RE: Norfolk Southern Pittsburgh Vertical Clearance Project (the Railroad Project), Determination of Effects Report (December 2022; Effects Report) prepared for Norfolk Southern Railway Company, by Michael Baker International, Inc

Determination of Effects Report (December 2022) Response

RE: ER Project # 2018PR13984.021, NORFOLK SOUTHERN PITTSBURGH VERTICAL CLEARANCE,
Department of Transportation (PennDOT), Pittsburgh City, Allegheny County

Diagram 1:
Allegheny Branch House Lofts
Site Plan

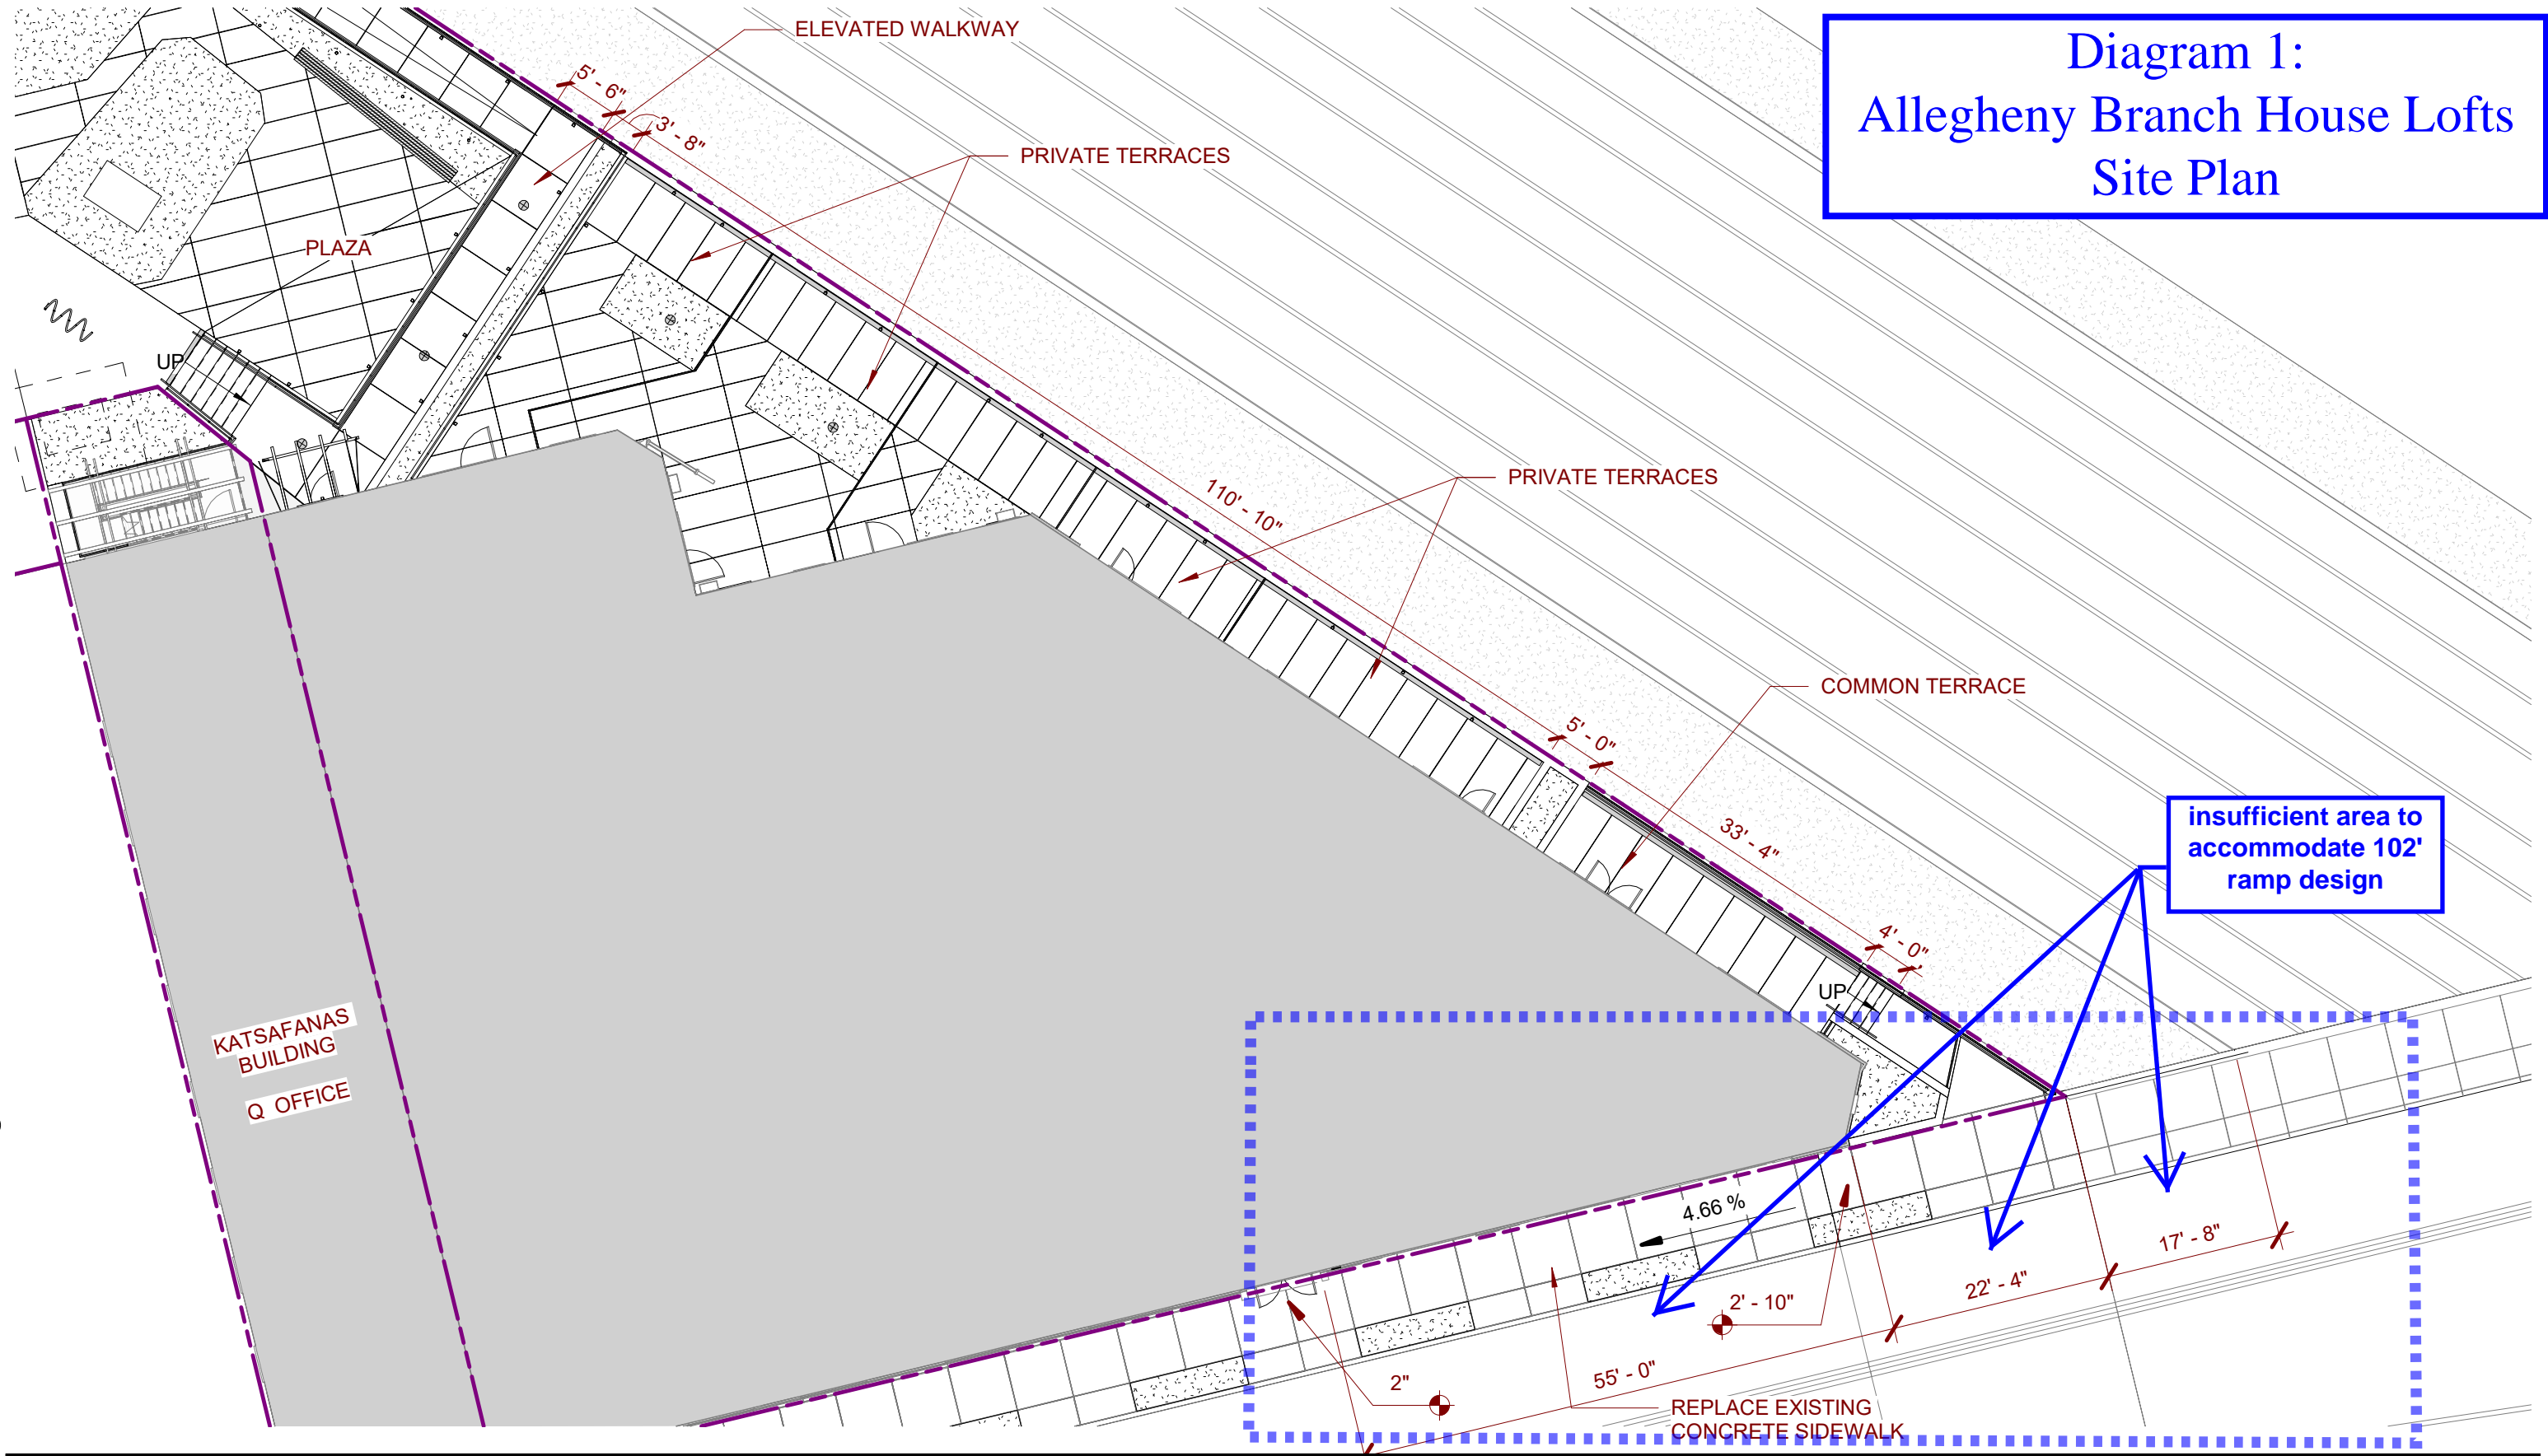
- ❖ The proposed 90' of ramps in three 30' sections at 8.3% grade plus two 5' landings is 100' in length. Further, a code required 1' handrail extension would also be required at each end, raising the total length needed to 102'.

- ❖ The attached measured drawings demonstrate that the distance for 102' of ramp and handrail is proposed for an area only 95' in length. The Preferred Alternative does not fit. (Diagram 1: Allegheny Branch House Lofts site plan)

- ❖ Even if the ramping could fit, the code-required handrail extension areas will interfere with operation of the existing front door.
- ❖ Building code require ramps at 8.3% grade to feature handrails on both sides. Incorporating these handrails and their impact on narrowing of the sidewalk has not been accounted for in the Preferred Alternative.

Diagram 2:
Acoustic Barrier Proposed Location

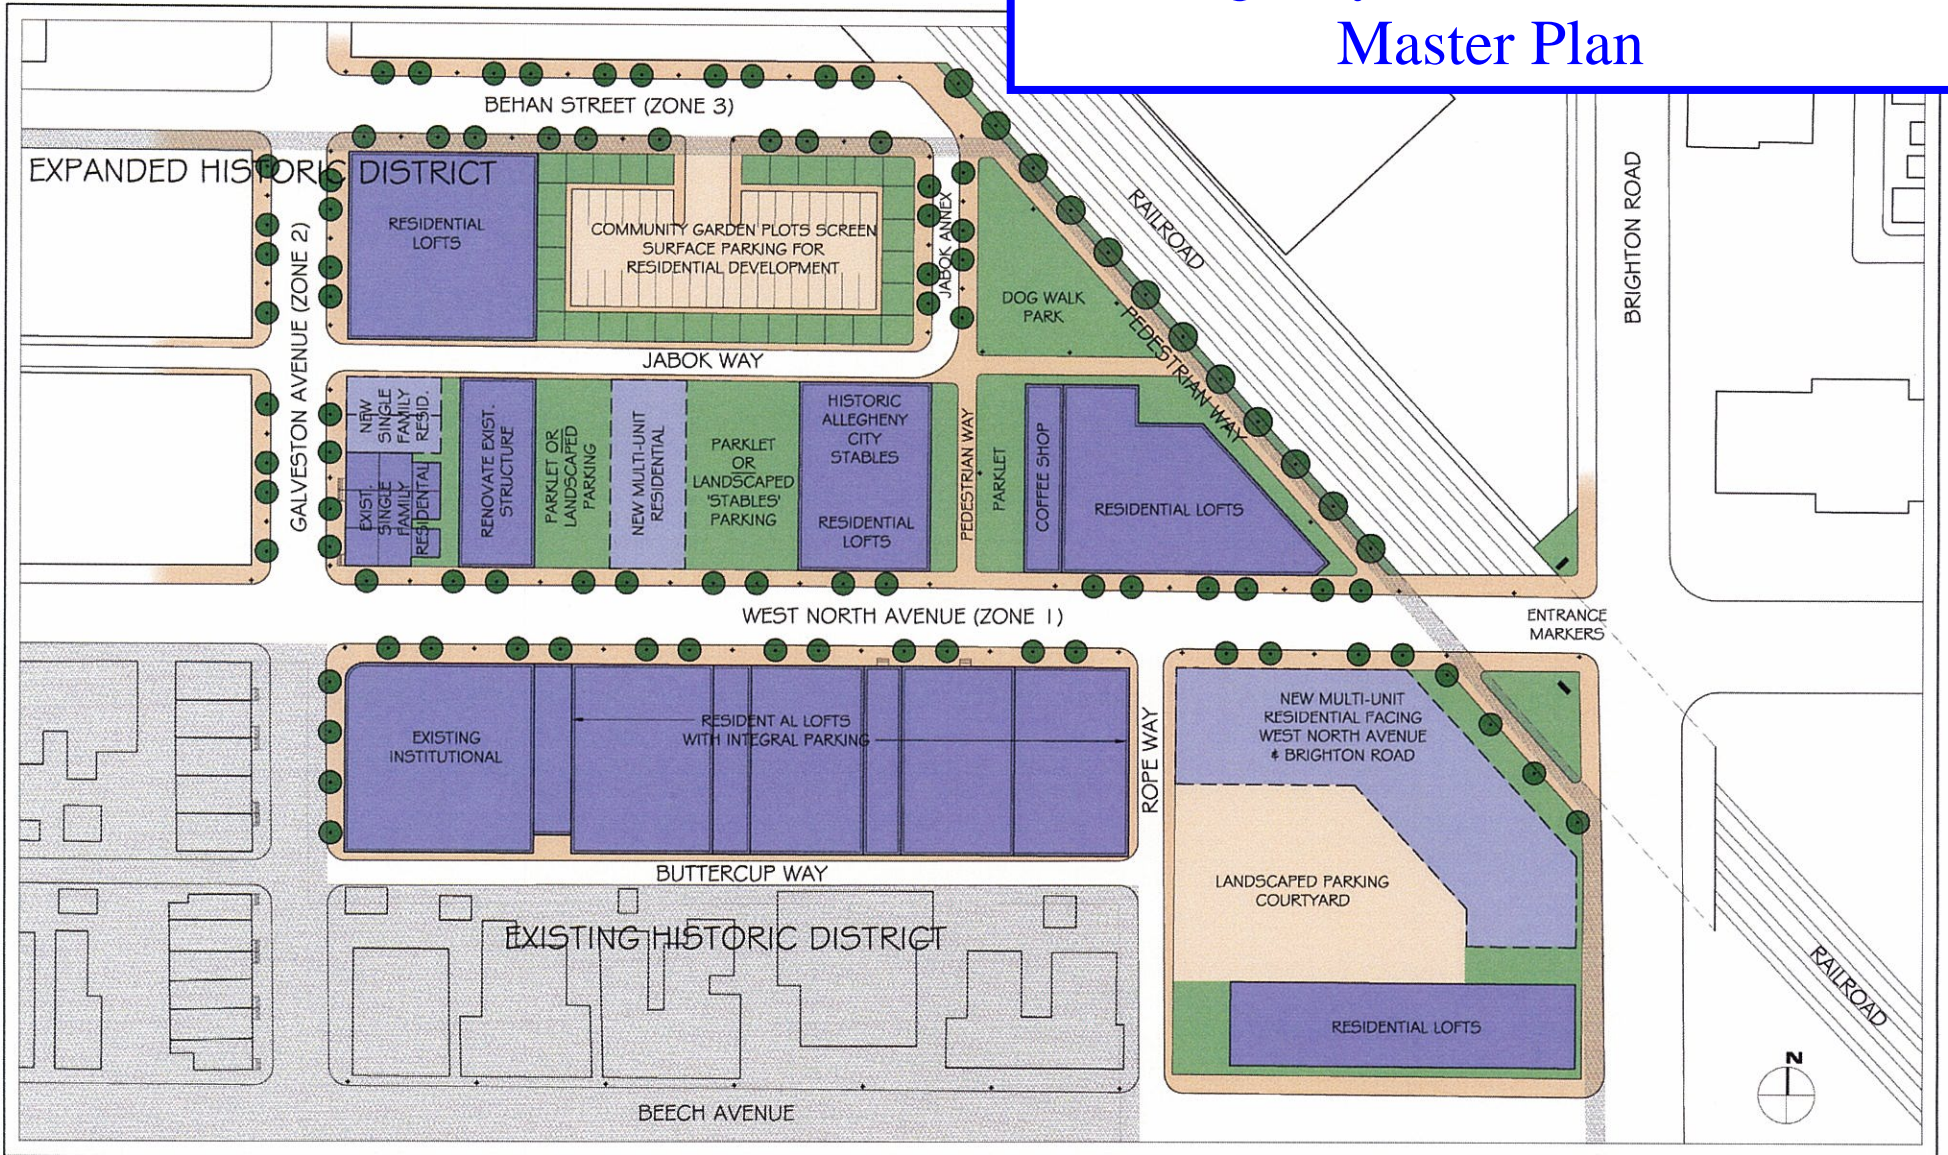
To minimize the Adverse Effect acoustic impacts to the NRHP-listed International Harvester building, it is suggested that a 48” vertical retaining wall be constructed adjacent to the existing railroad corridor bridge. The installation of this wall will deflect much (though not all) of the additional noise around the building from the louder, longer and increased rail traffic. See attached Diagram 2 for the proposed location of acoustic barrier.
